DOCKETED	
Docket Number:	26-IEPR-03
Project Title:	Electricity and Gas Demand Forecast
TN #:	272816
Document Title:	Teresa Cheng Comments - Industrious Labs, Earthjustice, Sierra Club, The 2035 Initiative at UCSB Comments on AAFS 6
Description:	N/A
Filer:	System
Organization:	Teresa Cheng
Submitter Role:	Public
Submission Date:	9/16/2026 9:57:54 AM
Docketed Date:	9/16/2026

Industrious Labs, Earthjustice, Sierra Club, The 2035 Initiative at UCSB Comments on AAFS 6

Re: Comments on Industrial Electrification Modeling in AAFS 6

Figure 1. Cumulative natural gas consumption of California manufacturing by end-use temperature, 2014. Petroleum and coal products account for the large majority of consumption above 200°C.

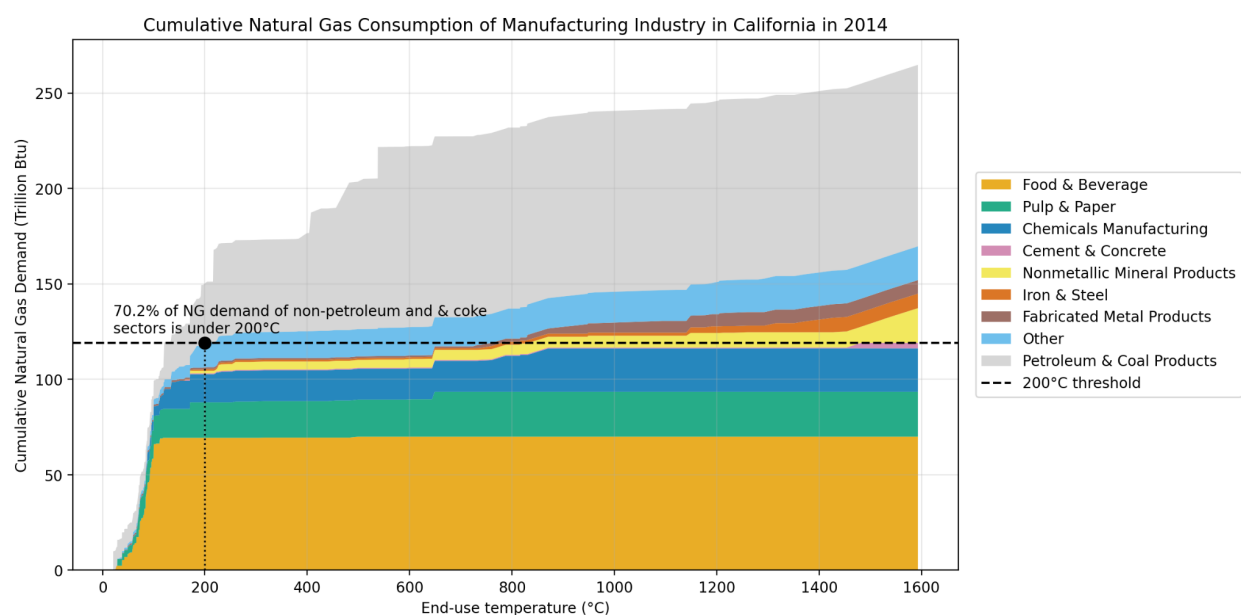
AAFS 6 assumes that thermal energy at or above 200°C does not electrify, and applies electrification rates reaching only 22 percent for heat demand below 100°C and 8 percent for heat demand between 100°C and 200°C by 2050. Multiple considerations suggest these assumptions are more conservative than the evidence supports.

First, the aggregate share of high-temperature heat across all manufacturing overstates the share in the industries AAFS 6 is modeling. High-temperature process heat is a substantial share of California industrial thermal load overall, but that aggregate is heavily driven by petroleum refining. Excluding refining, approximately 70 percent of California industrial heat demand falls below 200°C.ⁱⁱ Fuel consumption shows the same pattern: food and beverage, pulp and paper, and chemicals account for roughly 69 percent of California manufacturing natural gas demand excluding refining, against 44 percent when refining is included.ⁱⁱⁱ The fuel consumption figures derive from federal reporting data covering facilities above the 25,000 metric tons CO₂e/year threshold and therefore exclude smaller manufacturers, whose processes are generally lower-temperature. The Demand Scenarios already treat refining separately, reducing its overall energy demand as petroleum product demand falls, so this sector follows a different trajectory than the industries AAFS 6 is modeling. A high-temperature share calculated across all industries including refining therefore overstates the constraint facing the industries this scenario is modeling.

1. Raise the projected electrification adoption rates and assign an electrification pathway above 200°C reflecting commercially available high-temperature electric technologies.
2. Apply the federal policy discount only to the years federal incentives were expected to drive adoption, and account for the new MDI. Otherwise, present the undiscounted case.
